## PLANNING COMMISSION MEETING

Project Name: Jax Kar Wash  
 Description: Planned development agreement and final site plan approval  
 Date on Agenda this packet pertains to: May 21, 2026

**RE: Jax Kar Wash- Final Site Plan/Final Engineering Plan Review – 2<sup>nd</sup> Review**

**Final Site Plan / Planned Business Review  
for  
White Lake Charter Township, Michigan**

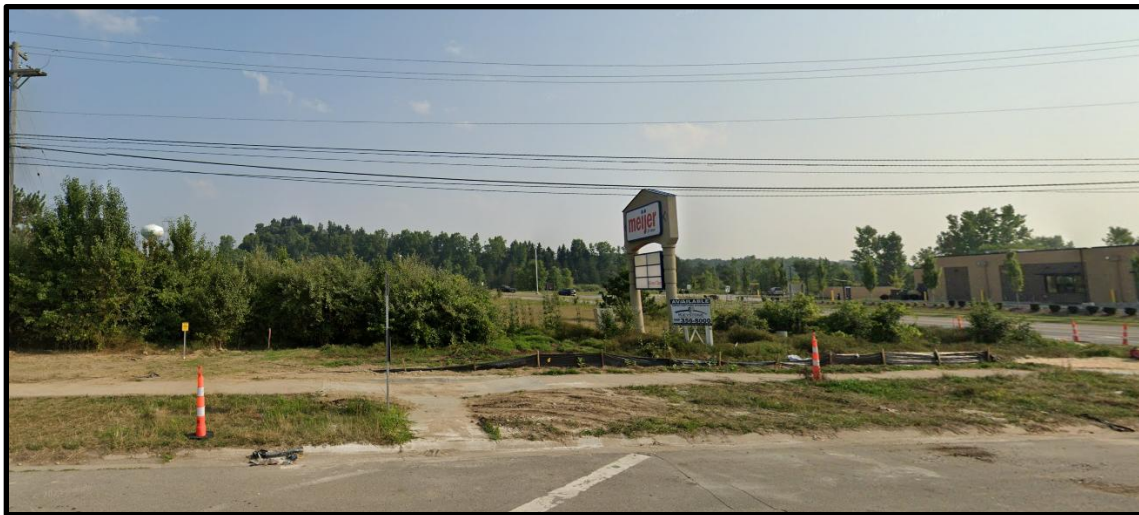
The site is served by water or sewer. Sheet C-6.0 provides a preliminary utility layout. Section 4.11.D requires site drainage to be designed in a manner that does not create runoff into neighboring properties or roadways. We defer to township engineering to assess the proposed utility systems.

A circulation plan was provided for emergency vehicles on Sheet C-3.1. We defer to Township Public Safety to determine the feasibility of site design and hydrant placement.
